**Review of the  
U.S. Department of Energy Responses to the  
U.S. Nuclear Regulatory Commission  
Requests for Additional Information on the West  
Valley Demonstration Project Phase 1  
Decommissioning Plan**

Prepared for  
**New York State Energy Research and Development Authority**  
West Valley, New York  
December 14, 2009

Prepared by the  
**Independent Expert Review Team**

**Figure 1. Schematic for Exposure Scenarios Initiated by a Sub-Surface Source**

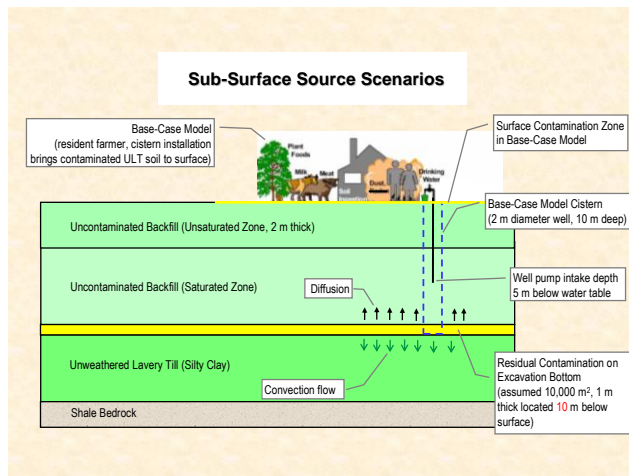
It is the understanding of this reviewer, based on the above, that DOE's response to RAI 5C6 relies on groundwater modeling which considers potential release of radionuclides from the bottom of a remediated excavation by diffusion. As noted in the second paragraph of my original comments on DOE Group 2 responses below, I consider such modeling inadequate. Instead, I expect contaminants from the bottom of each excavation to be drawn toward a pumping well completed within the backfill of the excavation not by a slow process of diffusion but much more rapidly by advection. Ignoring advection would underestimate the rate at which contaminants from the bottom of an excavation reach the well, thereby overestimating dilution and the derived DCGLs.

That such advection is disregarded is made clear by the recently submitted West Valley EIS/DPlan Calculation Package, Estimates of Human Health Impacts Due to a Sub-surface Source in the Vicinity of the Excavation at WMA1. As illustrated without ambiguity in Figure 1 of this package (reproduced below), (a) contaminants are taken to be released from the bottom of the excavation into the saturated zone of the backfill purely by diffusion, and (b) advective flow in Unweathered Lavery Till beneath the backfill is taken to continue being directed downward. In reality, a well pumping water from the saturated part of the backfill (pictured in Figure 1)

would cause groundwater flow, and hence advective transport, in the underlying shallow ULT to reverse course upward, through the contaminated bottom of the excavation (yellow in Figure 1), into the overlying (originally) uncontaminated saturated backfill, followed by lateral flow and contaminant advection toward the well.

The conceptual framework underlying the DOE revised calculations of contaminant transport from the contaminated bottom of a remediated excavation, through the originally uncontaminated saturated backfill, toward a well pumping water from the latter is fundamentally flawed and not conservative.

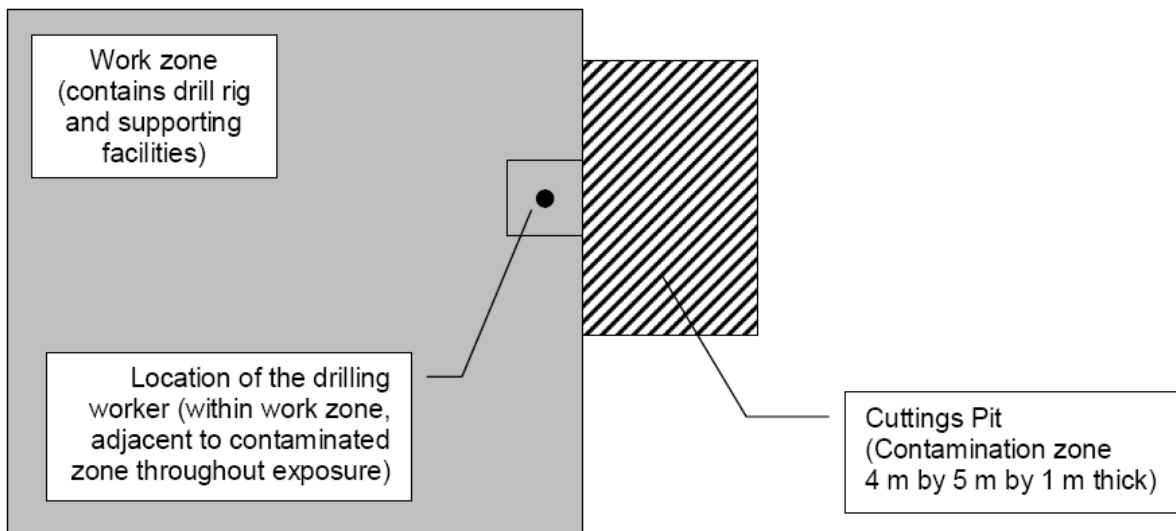
The RAI asked for a comparison of DCGLs for drilling a natural gas well with those for the cistern scenario. As the figure in the response shows (pasted below), the gas well was not drilled through contamination, so contaminated cuttings were not brought to the surface. It is not surprising that doses were low. The RESRAD files associated with this analysis were included in a zipped file. Since this analysis involves low doses from a borehole through uncontaminated soil, it is both uninteresting and not surprising.
